Access Compliance Report

Public Rights-of-Way

Intersection ID: 12202	Main Street: E_12TH_ST	Cross Street: N_ALEXANDER_ST	Location: N
ADA ID: 4C3A0AC8FC91	Ramp Type: Perp	Initial Pass/Fail: Fail	Overall Compliance: No
			Severity Score: 46.25

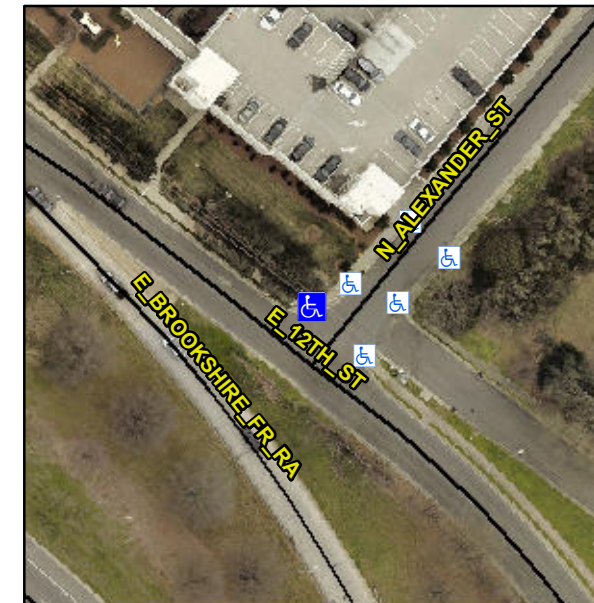
R304.5.1, R304.2.2, R304.5.3

Compliance	Description	Data	Compliance	Description	Data
N/A	Ramp Length (in)	68.0	No	Ramp Slope (%)	9.3
No	Ramp Width (in)	44.0	No	Ramp XSlope (%)	11.1
N/A	Flare Type LT	N/A	N/A	Flare Type RT	N/A
N/A	Flare Slope LT (%)	N/A	N/A	Flare Slope RT (%)	N/A
N/A	Flare Traversable LT?	N/A	N/A	Flare Traversable RT?	N/A
N/A	Landing Length (in)	N/A	N/A	DWS Provided?	N/A
N/A	Landing Width (in)	N/A	N/A	DWS Contrast?	N/A
N/A	Landing Slope (%)	N/A	N/A	DWS Length (in)	N/A
N/A	Landing X Slope (%)	N/A	N/A	DWS Full Width?	N/A
N/A	Landing Curb? (Y/N)	N/A	N/A	DWS Offset (in)	N/A
N/A	Shared Landing?	N/A			
N/A	Gutter Ponding?	N/A	N/A	Gutter Slope (%)	N/A
N/A	Gutter Lip Ht (in)	1.5	N/A	Gutter X Slope (%)	N/A
N/A	Painted X Walk1?	No	N/A	Painted X Walk2?	N/A
	X Walk 1 Direction	To SE		X Walk 2 Direction	N/A
N/A	X Walk 1 Width (in)	N/A	N/A	X Walk 2 Width (in)	N/A
	X Walk 1 Slope (%)	9.8		X Walk 2 Slope (%)	N/A
	X Walk 1 X Slope (%)	3.7		X Walk 2 X Slope (%)	N/A

Remove & Replace Entire Ramp.
